Report: TAB REPORT
Function: Test, Adjust, & Balance
Date: 10/09/2024
Completed By: National TAB

PROJECT
09-30-24 SWEETGREEN HINGHAM , MA
(TAB, IAQ)

Project: 09-30-24 SWEETGREEN HINGHAM , MA (TAB, IAQ)

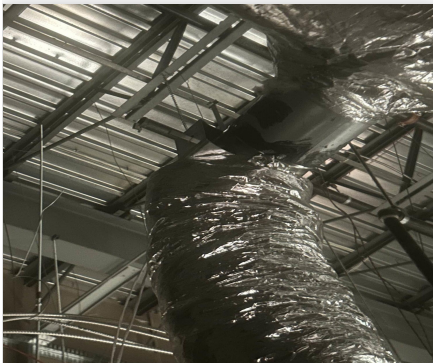
Issue Name : Damper Handle
Description : Damper handle for diffuser 2-5 is missing. Balanced flow setpoint marked on damper shaft for after install.
Created By : National TAB **Assigned To :** National TAB - Will Turnbough
Status : Open
Priority : Urgent **Asset Tag :**
Originated Date : 10/01/2024 - Gabe Merk - National TAB

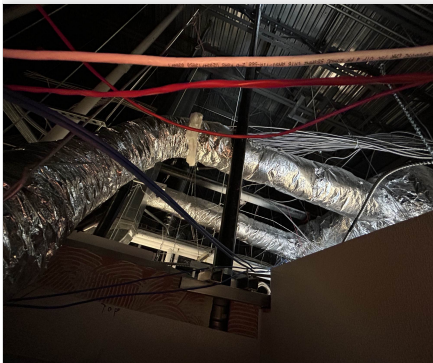
Issue Name : Gas Piping
Description : Gas piping to both RTUs is turned off. In order for unit to properly heat, gas will need to be available to the unit.
Created By : National TAB **Assigned To :** National TAB - Will Turnbough
Status : Open
Priority : Low **Asset Tag :**
Originated Date : 09/30/2024 - Gabe Merk - National TAB
